CITY PLAN COMMISSION STAFF REPORT

Chaves (Formerly SeaBiscuit)

- .1 - CD-CPC-2020-00065 – Rezoning.
- .2 - CD-CPC-2020-00066 – Signage Plan.
- .3 - CD-CPC-2020-00067 – Development Plan.

Project: Chaves Development

CHAVES DEVELOPMENT
 DEVELOPMENT PLAN
 SNYDER & ASSOCIATES
 ENGINEERS & PLANNERS, INC.
 www.snyder-associates.com

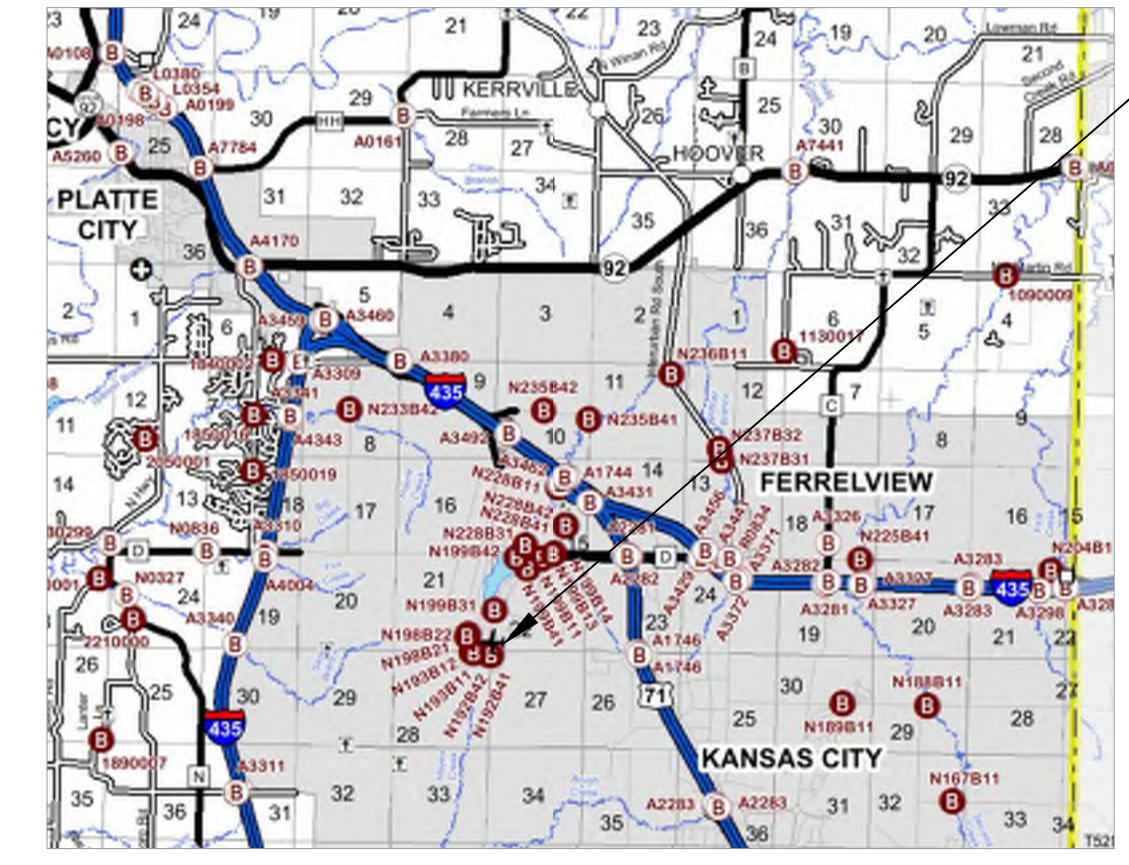
Staff recommends that the plan be revised show the proposed trails and connections to the trail from this development.

1. We had asked to see labeled sidewalks on the plans and that shows a connection from the proposed office building to the mixed use area and an overall pedestrian system that shows connection from the development sites to the public ROW. If you have this now, please label it and if not, please add it to the plans. (4/29/2022)

CHAVES DEVELOPMENT
 COUNCIL APPROVED SIGNAGE PLAN
SNYDER & ASSOCIATES
 ENGINEERS & PLANNERS, INC.
 www.snyder-associates.com

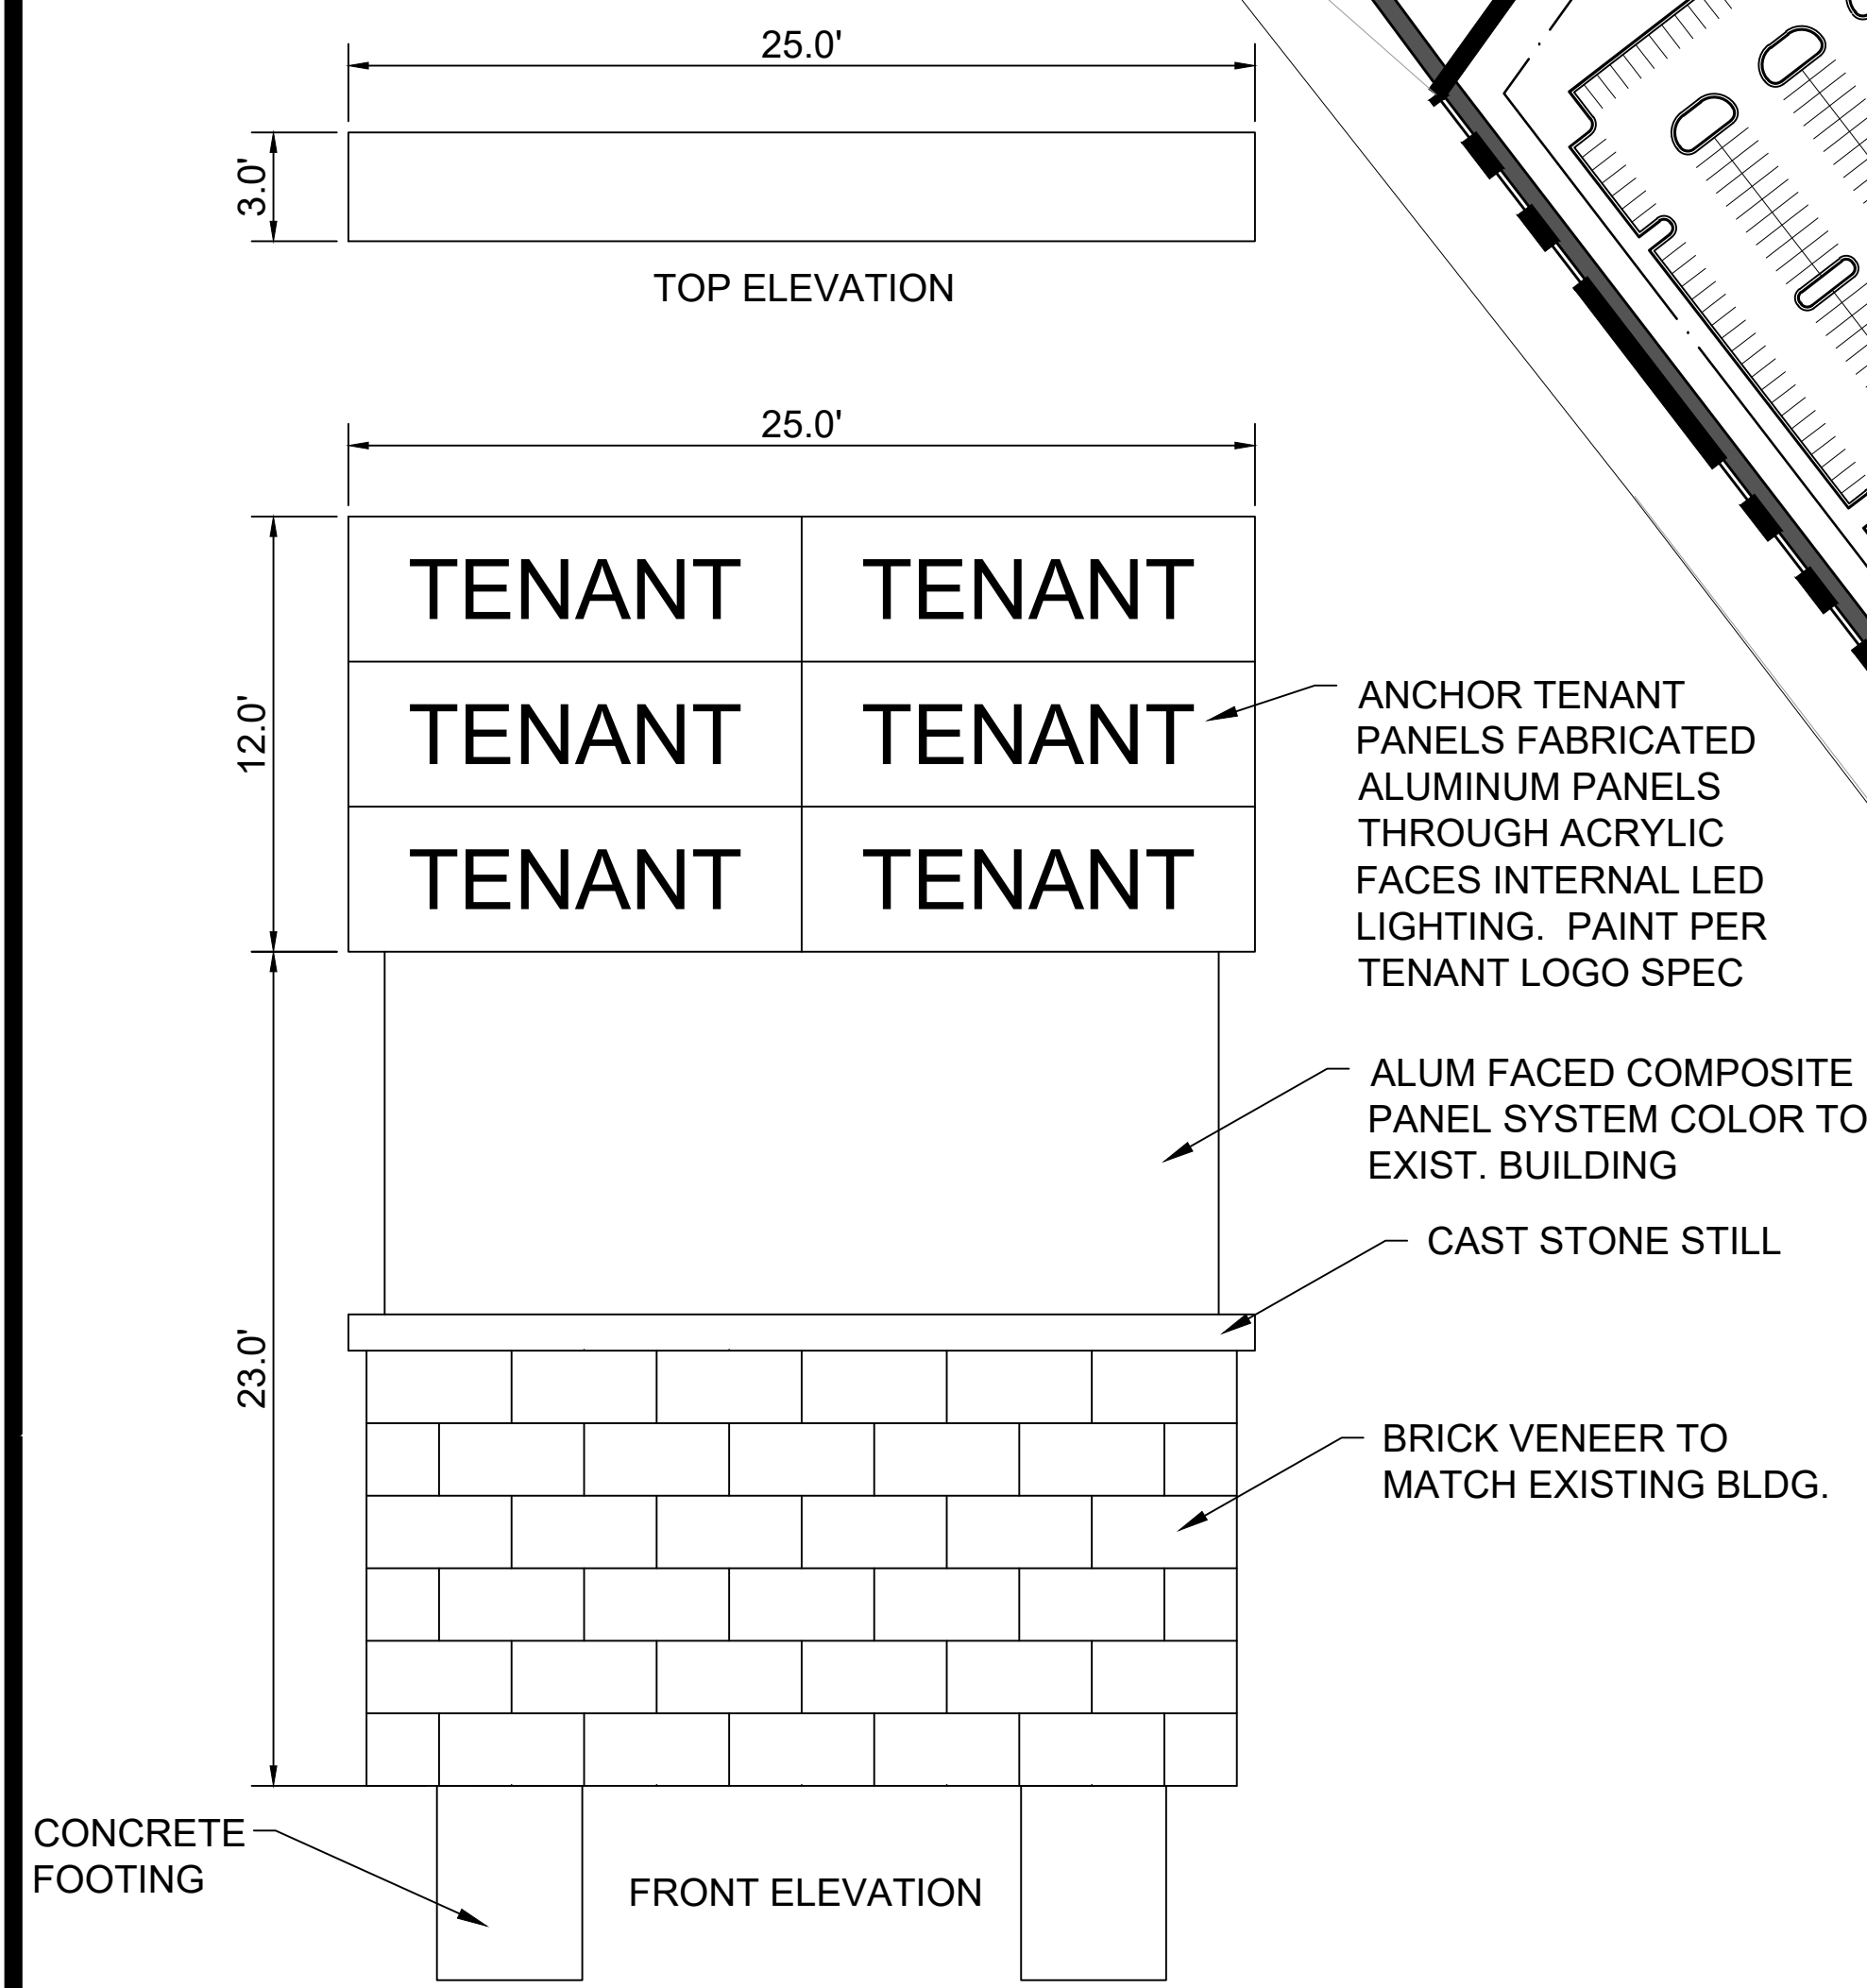
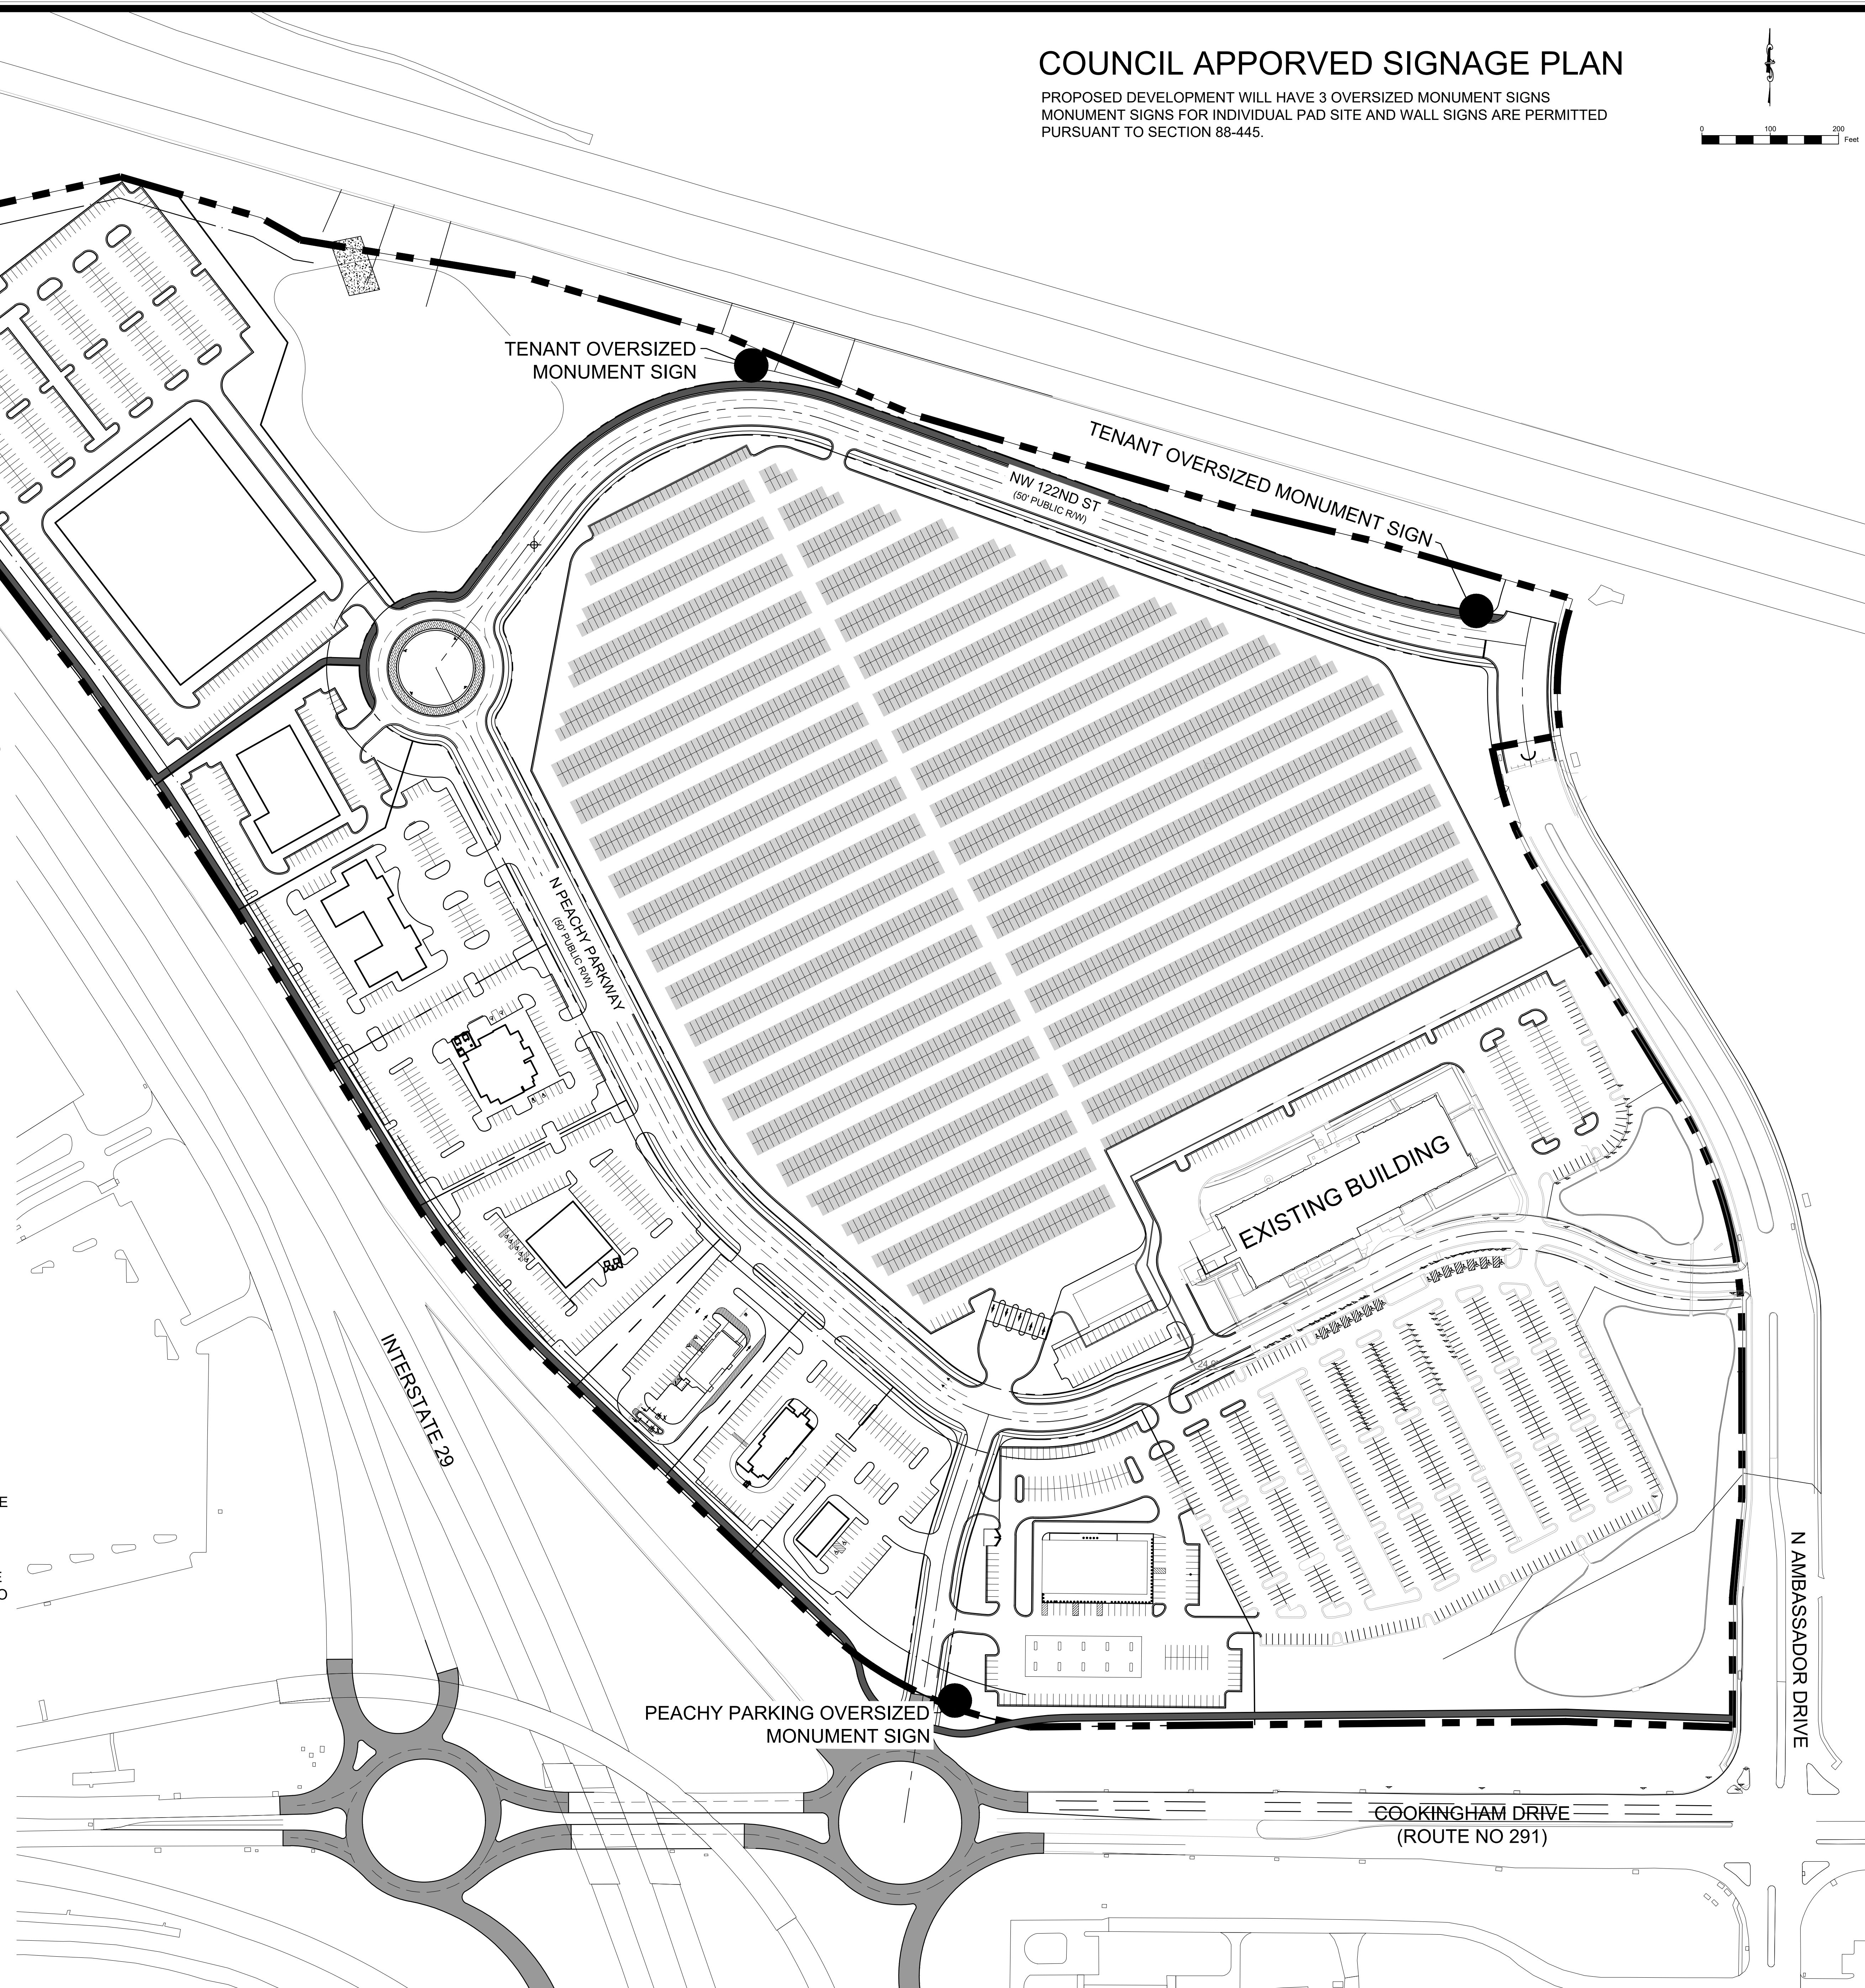
Case No. CD-CPC-2020-00066 is a request for approval of a Council Approved Signage Plan in District B3-3 (Community Business - 3) pursuant to Section 88-445-11 to allow for three oversized Monument signs as part of the Chaves Development. The proposed signs are 35 feet in height and 300 square feet in size. The signs are proposed to be constructed of aluminum faced composite materials on a brick base with and aluminum clad composite middle to match adjacent buildings. The main entry sign will be a single user sign and the other two signs will have up to 6 tenant panels. The signs must be setback 20 feet from the property line. Staff recommends some revisions to show the actual sign (25' wide) on the site plan.

The applicant is proposing to install several oversized monument signs as a companion case. Staff recommends that the plan be revised to properly show locations of all proposed signage for this development. The revised plan shall be approved prior to ordinance request.

1. Provide an approximate timeline of when each oversized monument sign will be constructed with the phases of the related Development Plan. (5/12/2022)
2. Staff recommends that the southwest sign should incorporate multi-tenant signage as well. It is the closest to the interchange and major intersections as well as the western main drive to the development. (5/12/2022)
3. Assuming the paid parking lot is constructed first, what will the anticipated colors be of those that say to match the existing building? The existing office tower or proposed commercial buildings? (5/12/2022)

4. If the associated Development Plan (CD-CPC-2020-00067) should expire, this associated Council Approved Signage Plan shall be deemed expired as well. (4/27/2020)
5. The proposed oversized monument signs shall not be constructed into the associated lot or tract of land where the sign will be placed is platted. (4/27/2020)
6. No oversized monument sign permit shall be issued until permits for Phase 1 of the development are issued to constructed either necessary infrastructure or building permits. (4/27/2020)
7. Vacate the existing right-of-way for NW 122nd Ct in association with any future Final Plats. (4/29/2020)
